R765: Avoka, 31 Day St

RE: S92 LUC60370146 Response

Railings at ground floor precedent with vertical fins at 100mm CRS: Westlight Apartments – 6 & 8 Wakumete Rd, Glen Eden, Auckland 0602

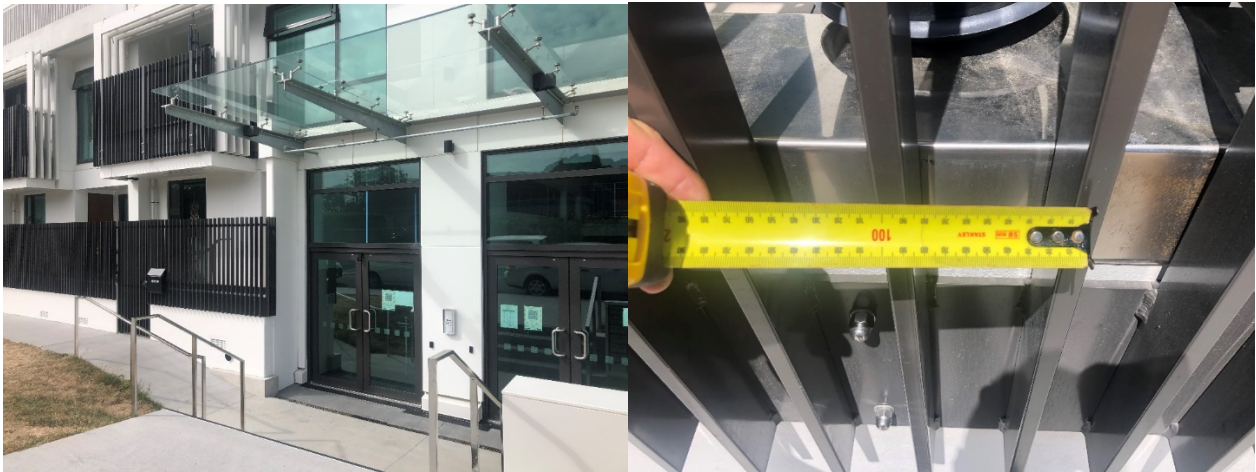
- Please provide a precedent image of the railing to the two ground floor units. It would be appreciated / is suggested that the northern elevation drawing is amended to add this image onto the drawing.

- Please confirm what is the general spacing between the metal fins of the railing. The desired outcome here is to provide only filtered views up from the pavement to the patios of the ground floor units while providing views out. This would suggest a narrower spacing for the fins of the railing.

Maximum spacing 100mm as shown in the precedent example.
